5TH & TRINITY HOTEL

- URBAN DESIGN COMMISSION -

Date: May 09, 2023
To: City of Austin Design Commission
From: Planning & Urban Design Working Group
Subject: Density Bonus Working Group review of 5th & Trinity Hotel for substantial compliance with the Urban Design Guidelines
Meeting date: May 03, 2023; 12:00 pm; Virtual Microsoft Teams Meeting
Applicant: Kelly Wright – Armburst & Brown, PLLC

- ① Light Pole
- ② Accent Lighting
- ③ Storefront Lighting
- ④ Canopy Lighting

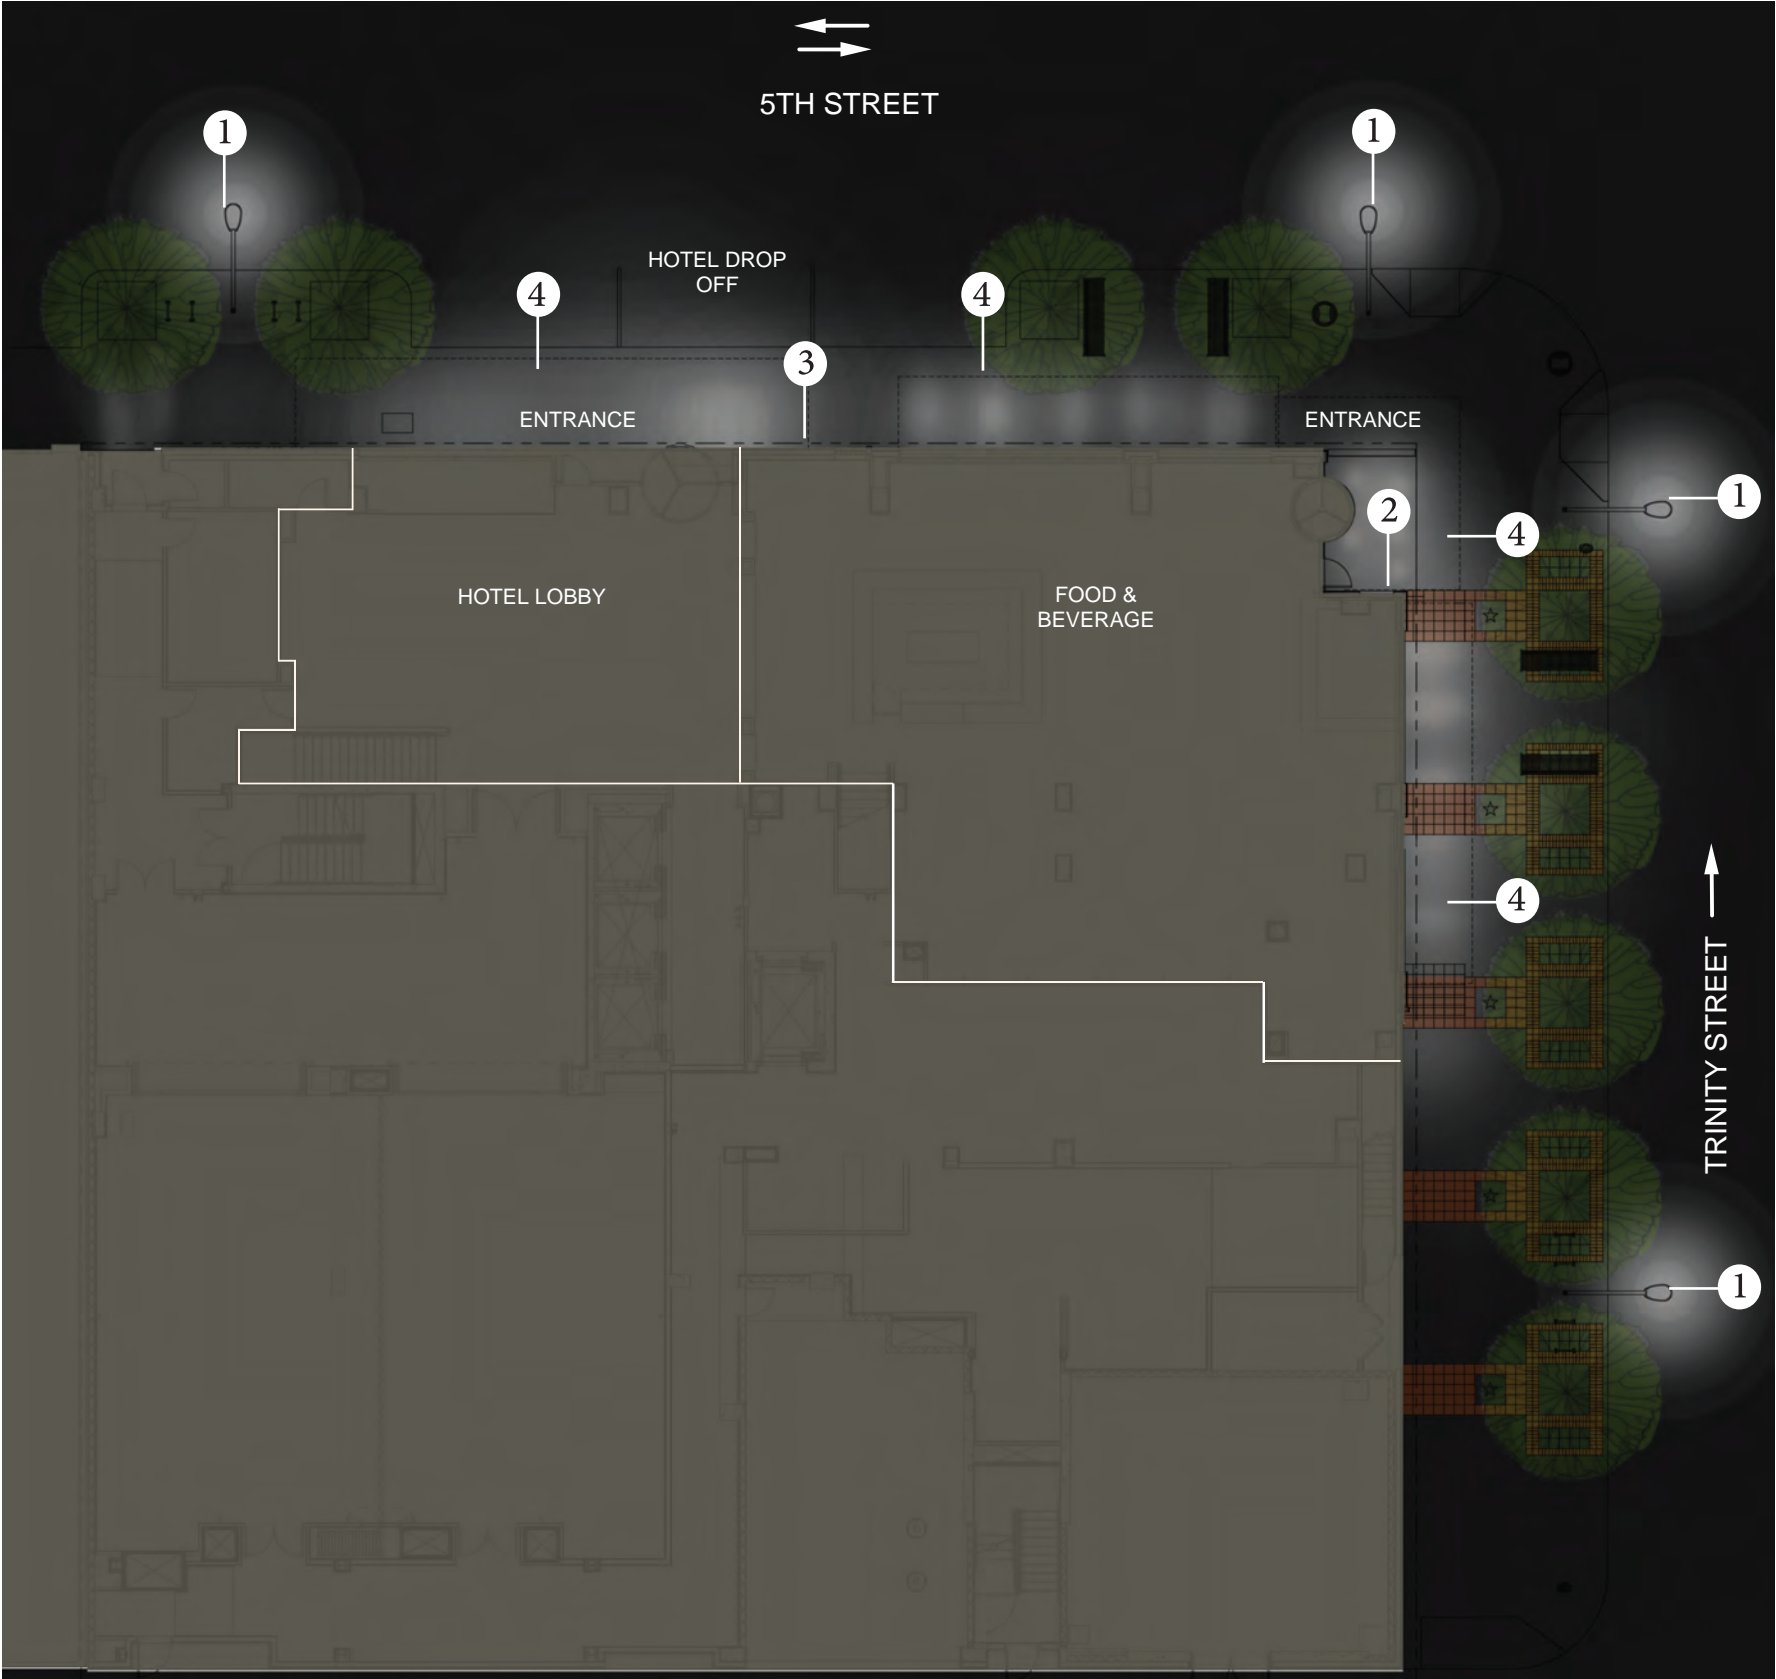
Lighting is shown in the illustrations do not comply with the Great Streets Program. Light fixtures in rendering do not match image of proposed lighting. Provide pedestrian scale lighting – fixtures and show lighting in renderings for full compliance

Comment: Provide additional information on lighting with correct fixture noted on back-up materials

- Is existing gooseneck light fixture on corner staying or being removed/relocated? Renderings show it being replaced by a historic fixture -Is this appropriate for the downtown streets?
